# CERTIFICATE OF APPROPRIATENESS PLACARD

Install metal roof over rear addition

804 W South St

COA-0204-2018

**1 DEMOLITION PLAN**

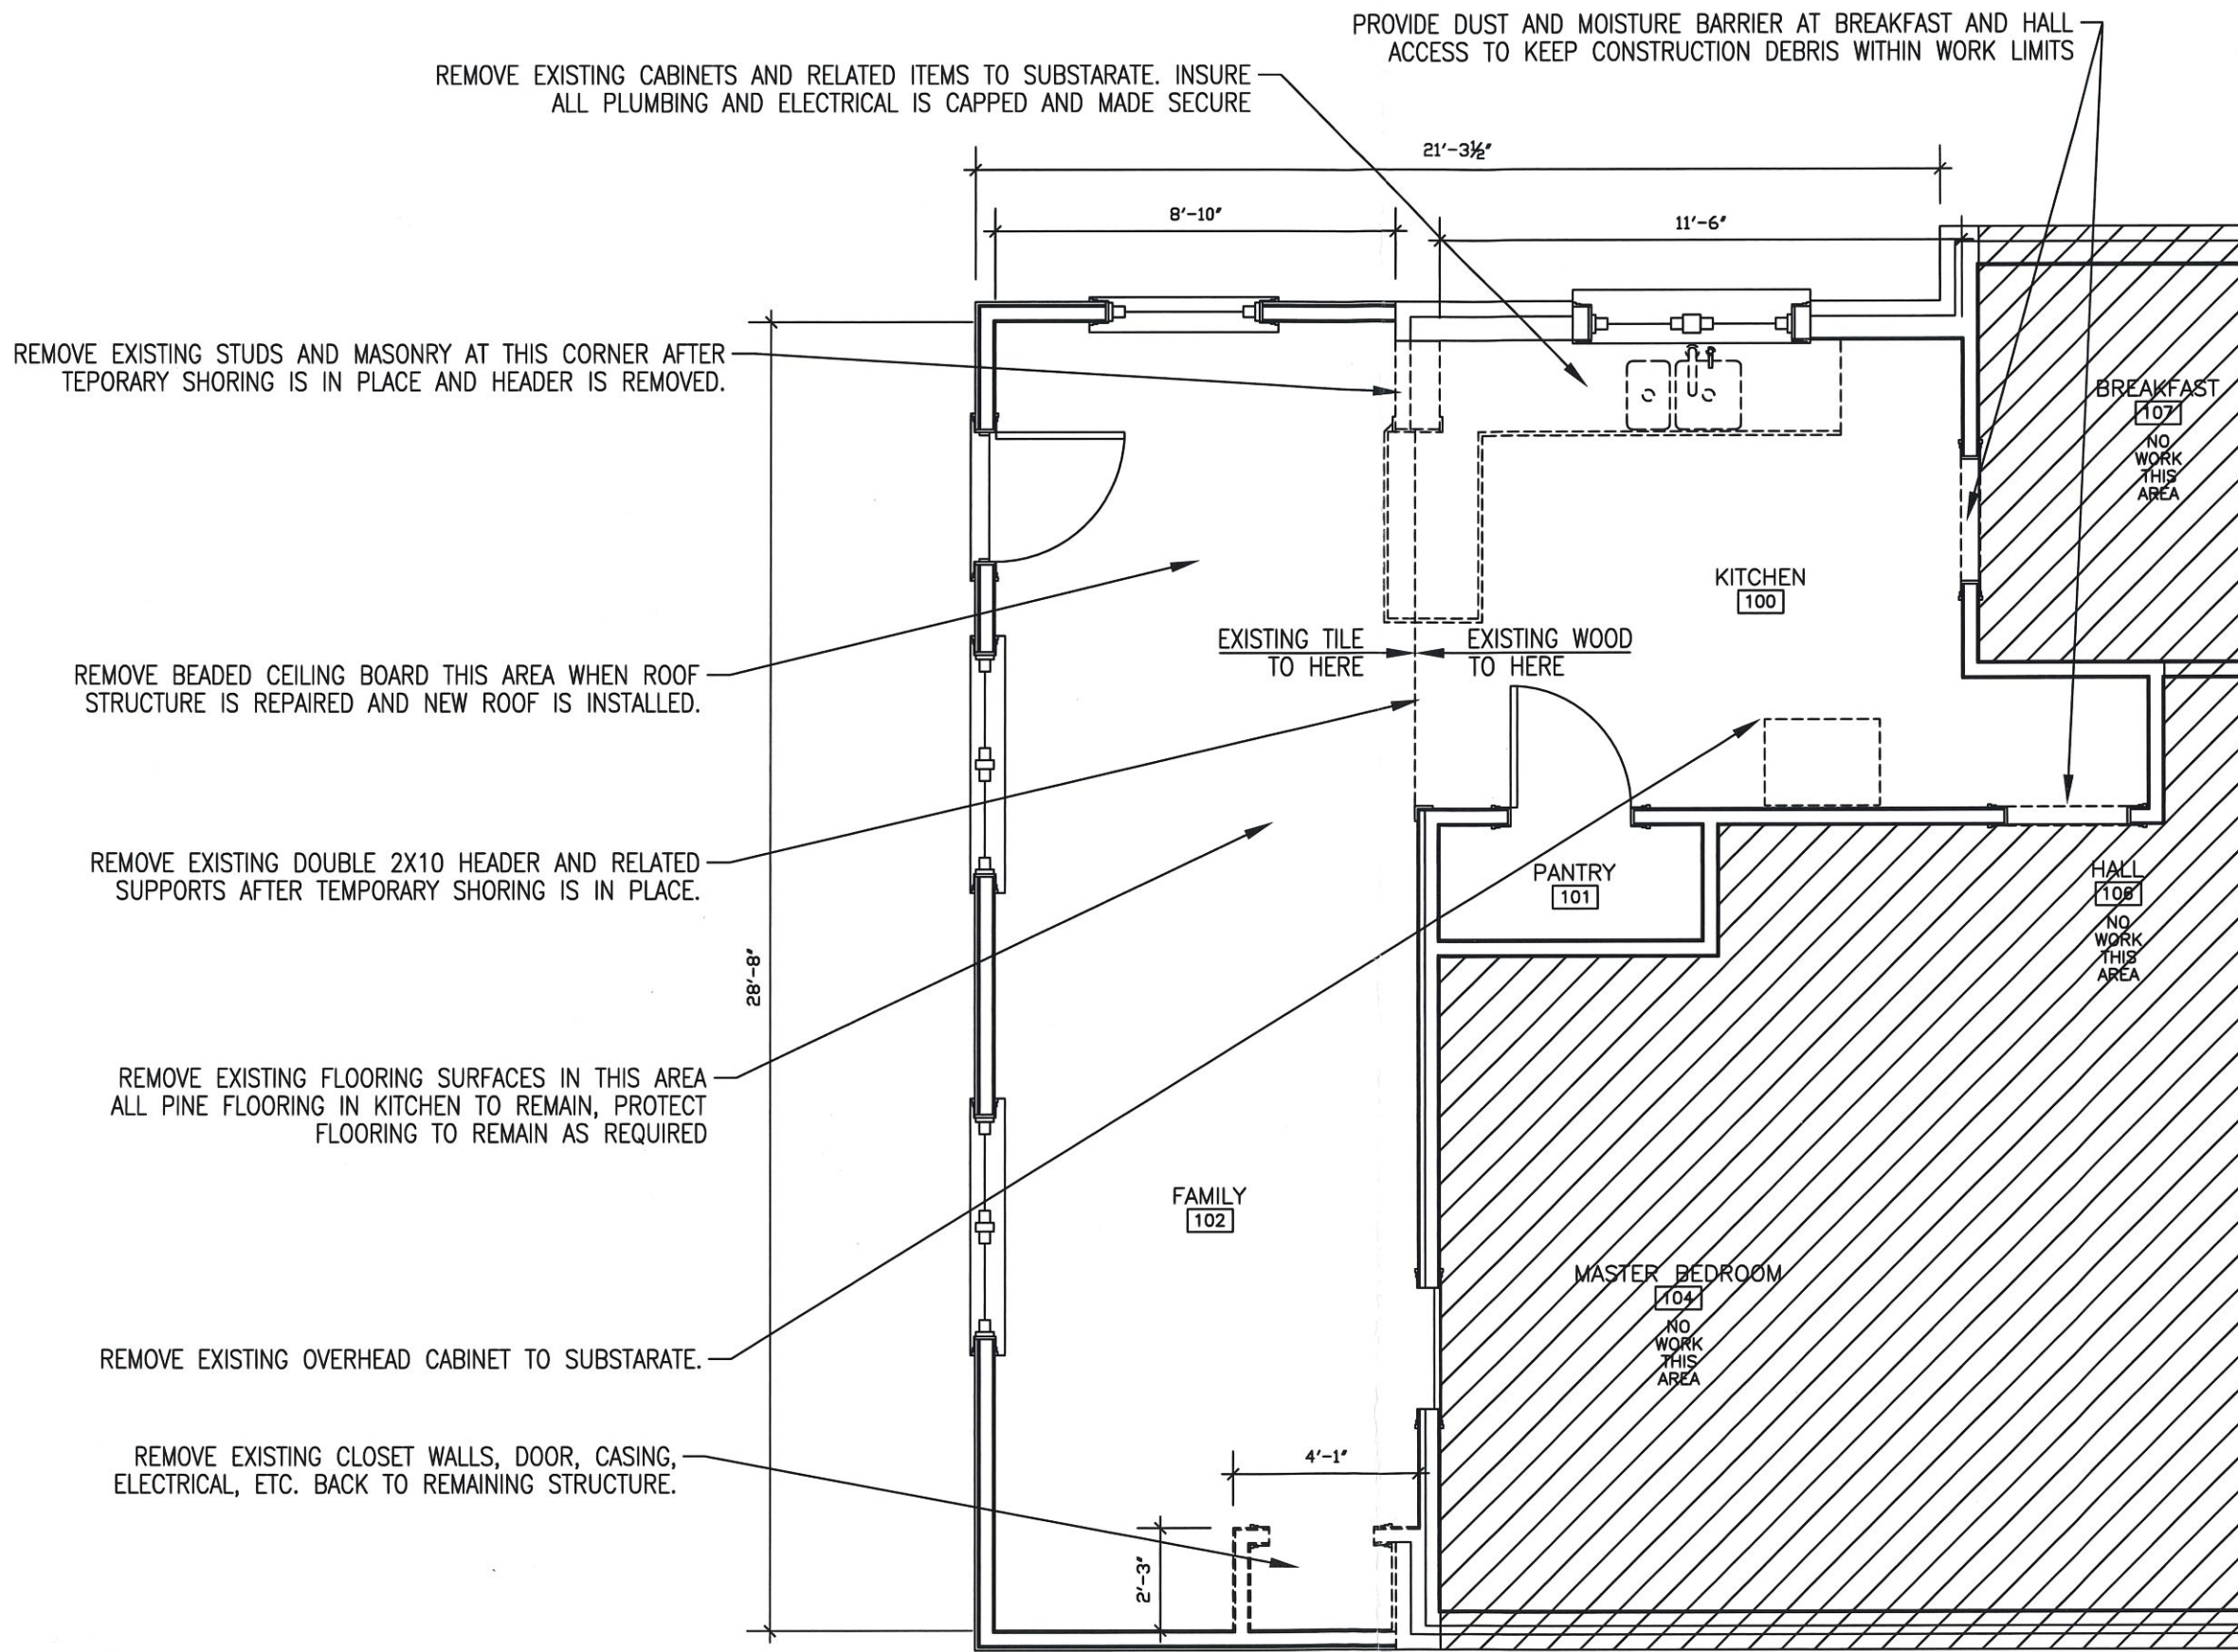
Thank you for this additional information. In reviewing the drawings once more, I did notice that it appears that a window is being added in the proposed laundry area. Please send a specification of the window to be installed (including a section). Additionally, the photographs you provided of the existing conditions are excellent. Please also provide elevations illustrating the proposed new roof slope of the addition and the wall with the new window.

Thanks for your quick reply. I have contacted the Owner about the proposed window and he stated that they have decided to delete it (see attached A-1 dated today). As far as the roof slope for the new metal roof, it will be the existing slope. The reason for the metal roof is the simple fact that the existing roof slope is too low for a shingle roof, thus the water infiltration/water damage issue.

WAKE CO. REG.	PAGE 114	B.O.M. 1885	C.N. = 8801	<b>ROBERT MAYHEW</b>	
				<b>CHRISTINE MAYHEW</b>	
				PART OF LOTS 186, 187 & 188 BOYLAN HEIGHTS 804 WEST SOUTH STREET RALEIGH NORTH CAROLINA	
				DATE: 05-04-2005	DWG. NO. A-6477

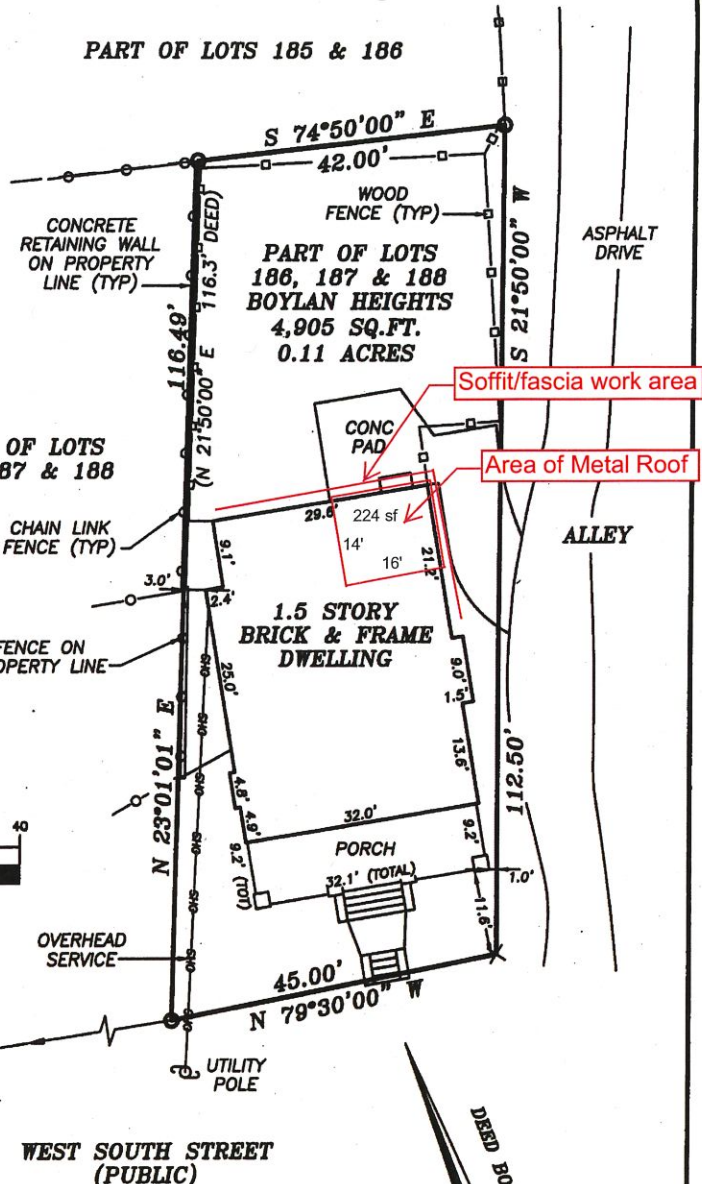
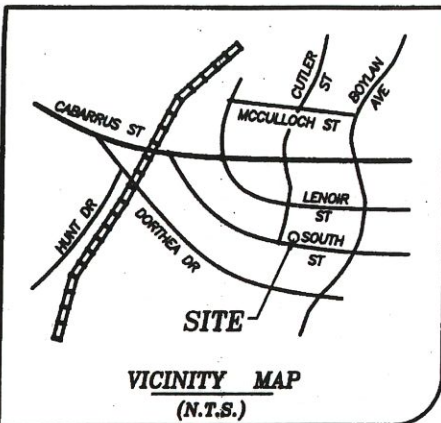
In addition to a little more information on that part, could you also provide a drawing that shows what part of the roof will be metal vs. remaining the same? ***See attached Survey that has the areas denoted.***

I'm reviewing your minor work COA application for a metal roof at 804 W South Street. In the written description it states "When the addition is reconstructed, all fascia, soffit, trim, fenestration, flashing, and gutter systems will be installed and painted to match the original structure." Will the exterior of the rear addition change in appearance in any way? Is the reconstruction due to the roof structural system? In addition to a little more information on that part, could you also provide a drawing that shows what part of the roof will be metal vs. remaining the same? This could be as simple as making notes on the plot plan.
